APPLICATION

SEWAGE DISPOSAL TESTING

STATE OF MARYLAND - DEPARTMENT OF HEALTH AND MENTAL HYGIENE 1000 gallons
DISTRICT 4th

PROPERTY OWNER Wyse S. Taylor

Field sheet

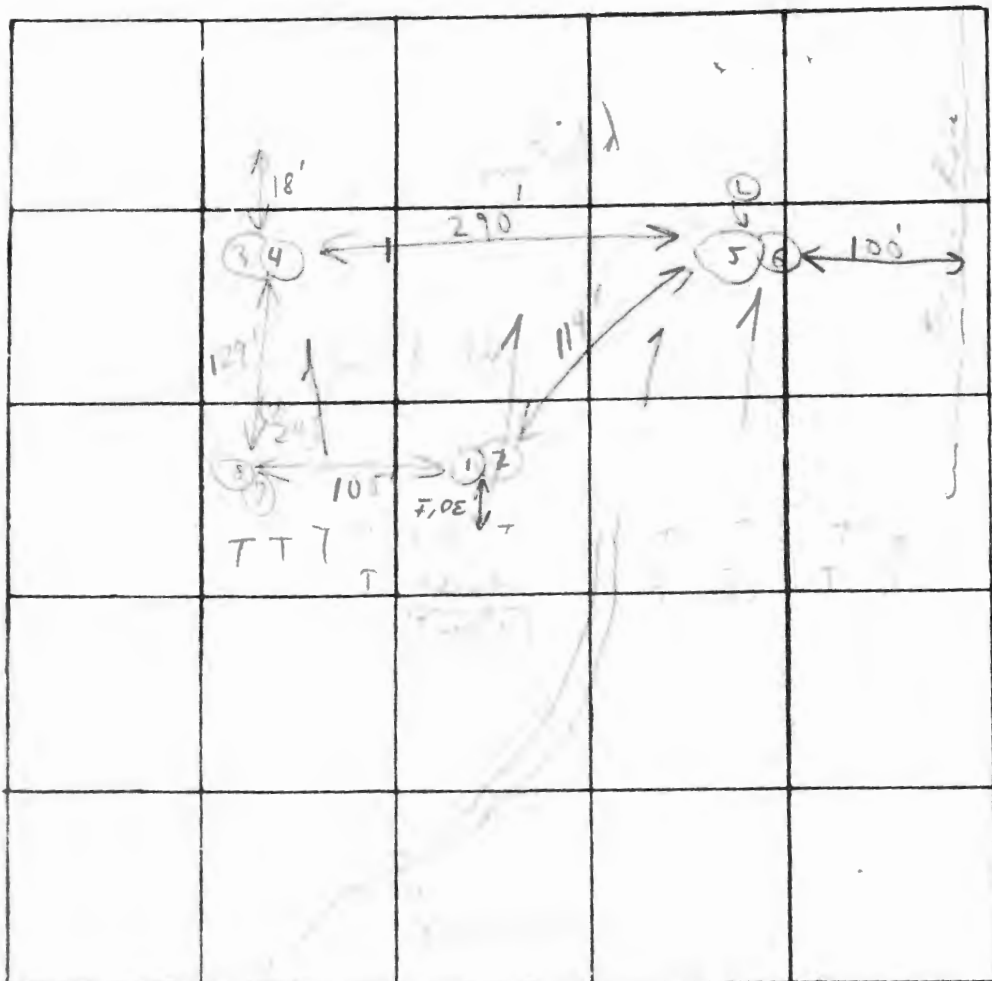
Dry well to have 125 sq ft effective absorbent sidewall area per bedroom below inlet. Inlet to be 3' below original grade and maximum depth 8'. Location per engineer's plat 500' down right property line section being 1245' in length from point of turn of line 313' and line 1245' and 145' in from right property line when of dry well & trench used

Spacing lot from Watersville Road. need: (1) 5' earth buffer between trench & dry well.

PROPERTY LOCATION: (2) 2 inspections of trench - before & after stone in trench.
SUBDIVISION _____ LOT NO. _____

7/20/78 REASONS FOR REJECTION OR HOLDING for certified holes by engineer
9/5/78 Certified holes reviewed by C.B.S. C.B.S.

APPROVED BY C. B. Streaker FOR Dry well & trench DATE 10/5/78
(KIND OF SYSTEM)
